## RFP Questions and Answers

### GMIA Ground Transportation Lot and Restroom

A206-16012

1/21/16

Sanitary and Water Utilities Near Cab Lot

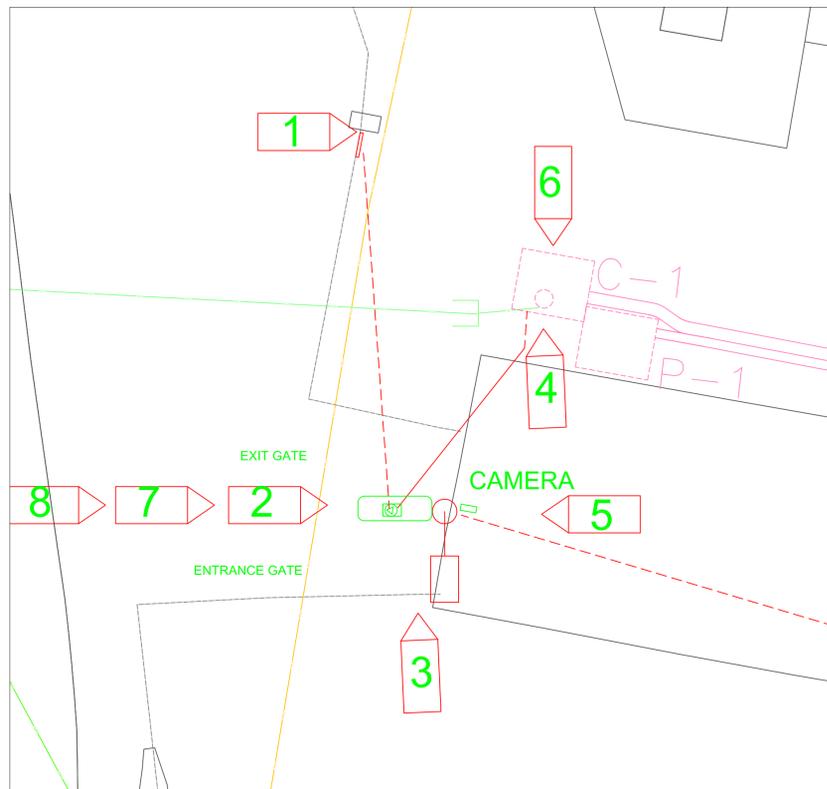
4. Please describe availability and location of potential utility connections: water, sanitary sewer, power, security, communications, etc.
  - a. See attached plans for a rough idea of connections available. The consultant is to verify all utility connections. There is water, sanitary, power, security and communications in the project vicinity.

11. The RFP notes GMIA will provide surveying needs. Is a survey available for viewing by consultants with location of utilities – sewer, water, gas, power etc ?
  - a. There is no survey completed yet. Our surveyor can pick up utilities and other items requested by the consultant. See attached plans for a rough idea of connections available.
